SUBJECT
Revised Project Description for Romani Solar Farm

Subject: SSD-67105475 Romani Solar Farm – Amendment to Project Description

Romani Solar Farm

F1 - Revised Project Layout

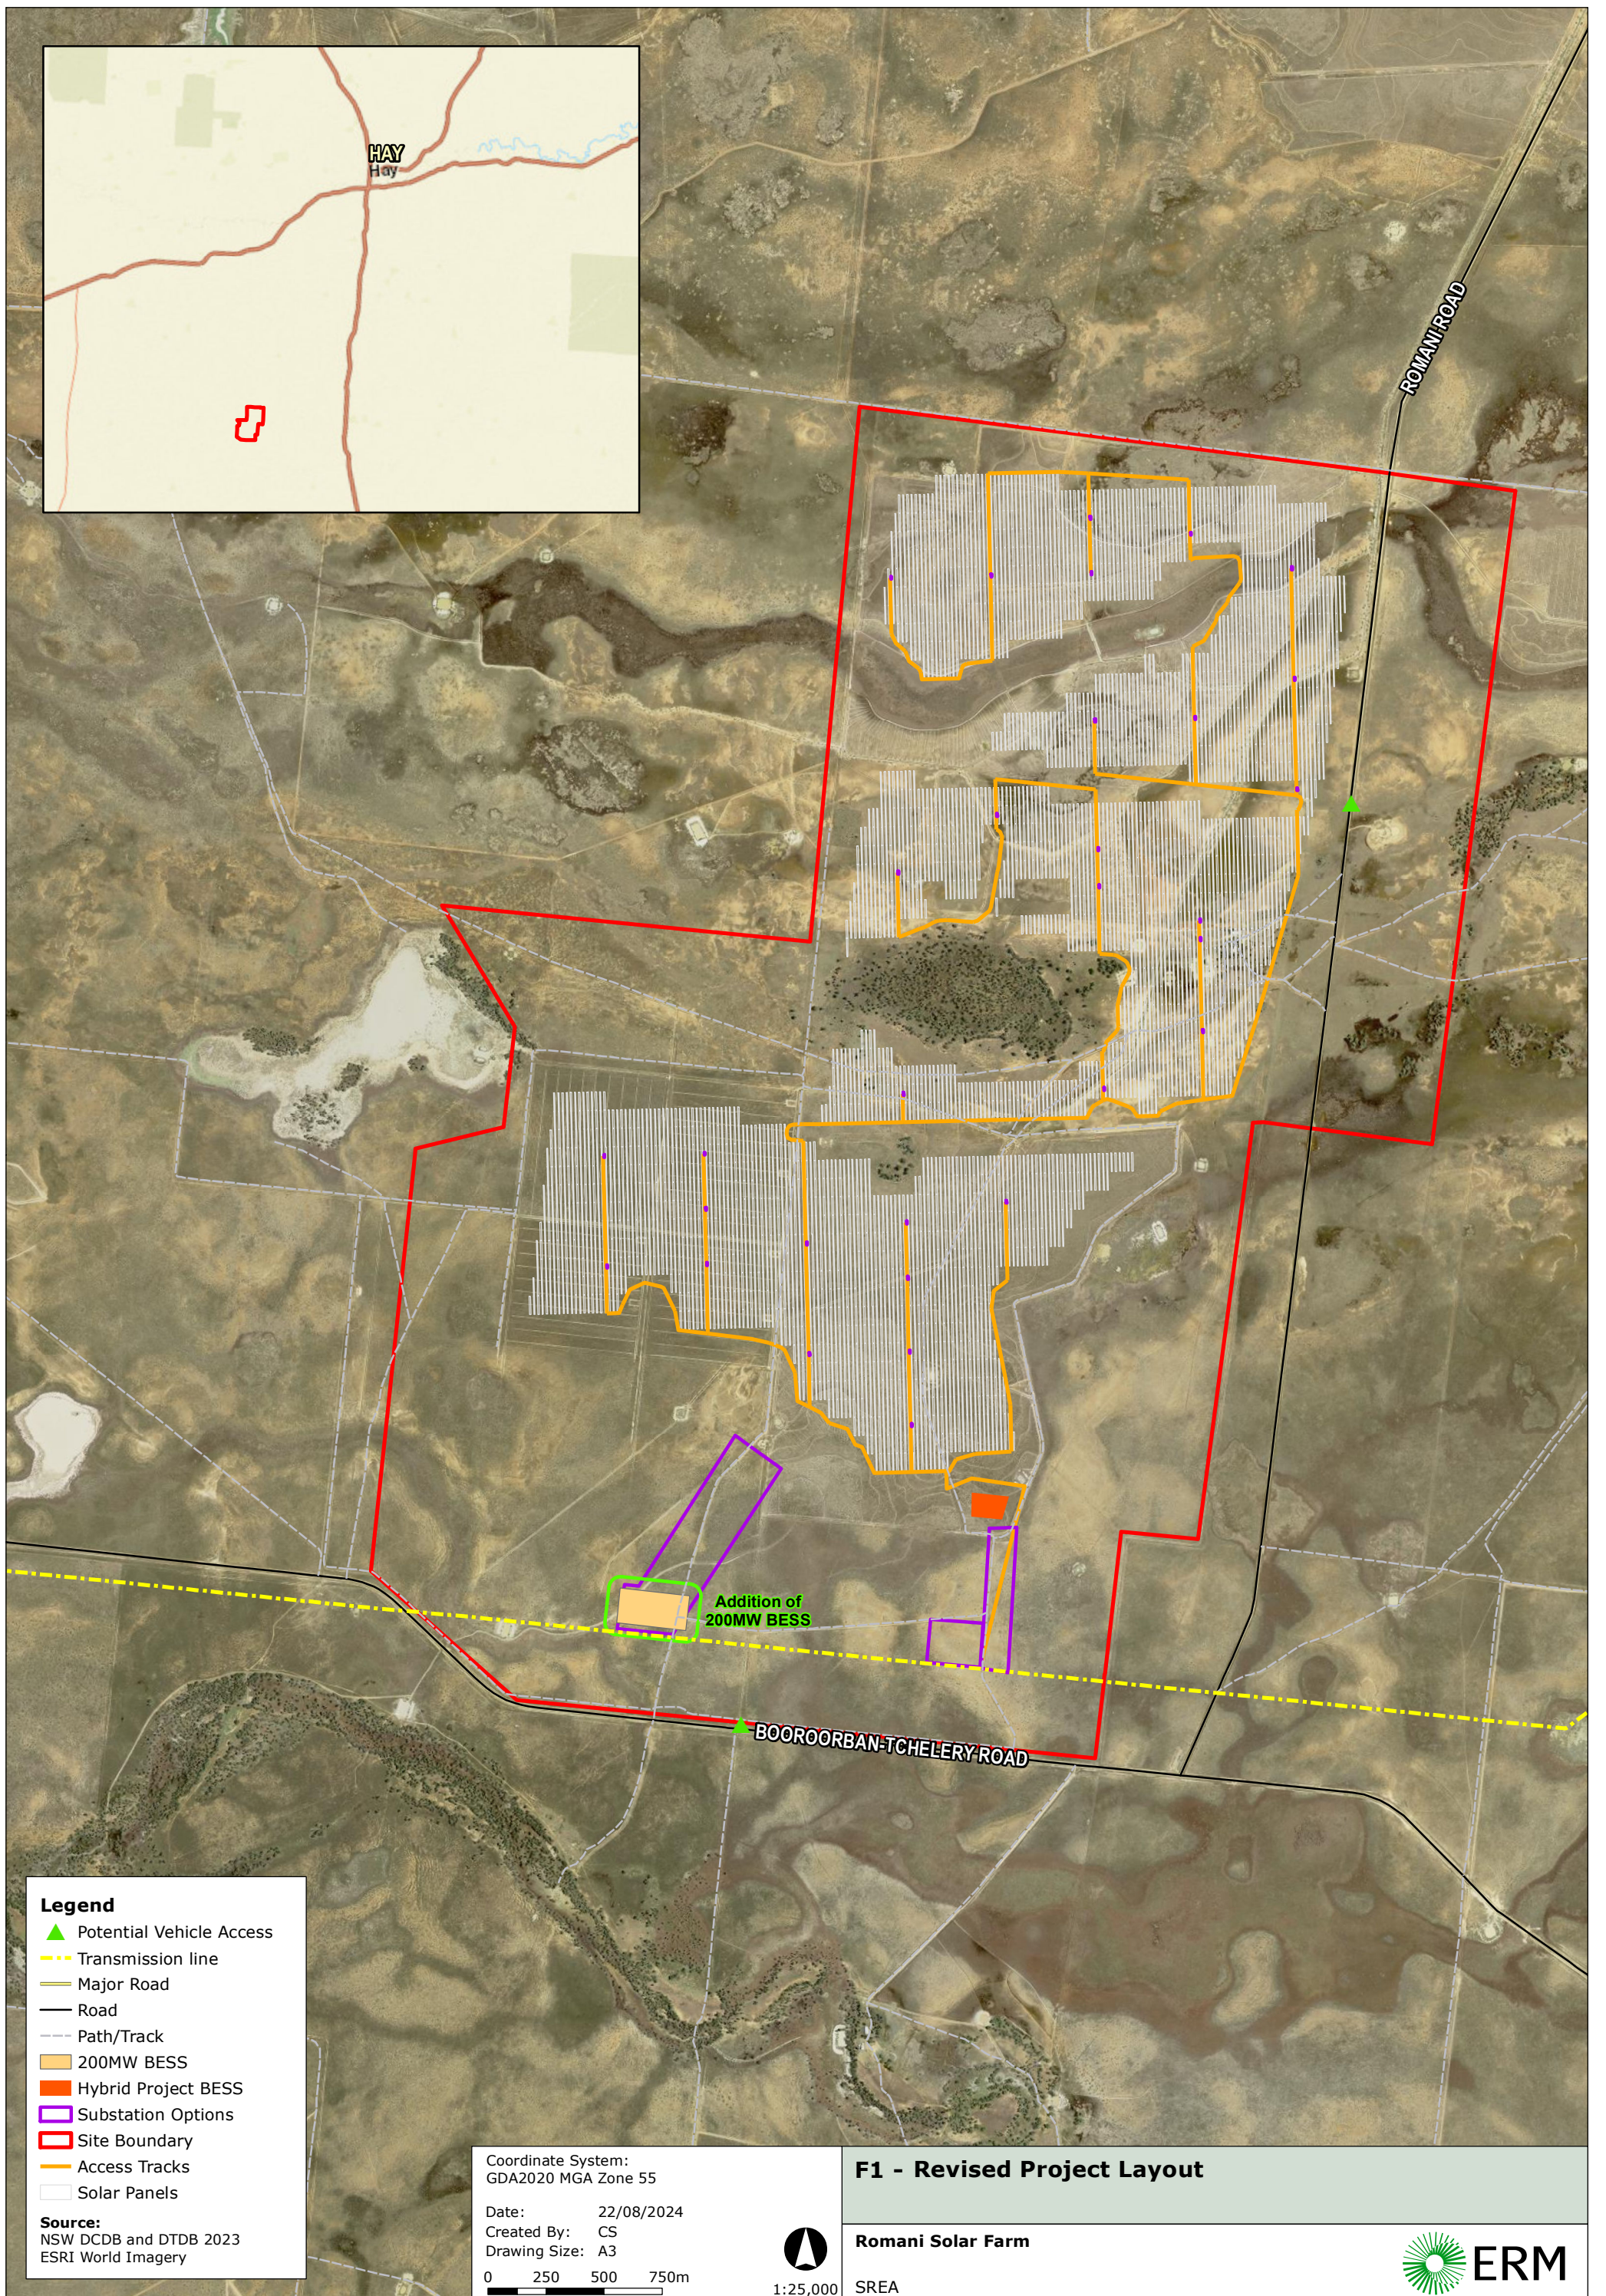
The revised Project will include a second BESS with storage capacity of 200 MW / 800 MWh and will be connected to the existing X5 transmission line (the X5 BESS). The Hybrid Project and the X5 BESS will be the subject of a single Environmental Impact Statement. Construction of the Project will be staged such that the Hybrid Project and the X5 BESS can be constructed separately, concurrently and/or independently depending on market demand.

The Project description, as revised, is detailed in **Table 1** below. The updated indicative project layout showing the Hybrid Project and X5 BESS is shown in

Since the preparation of the Scoping Report, SREA has optimized the design to avoid environmental sensitive areas to the north of the project area, including Aboriginal heritage sites and native vegetation. All EIS technical studies are considering the revised Project.
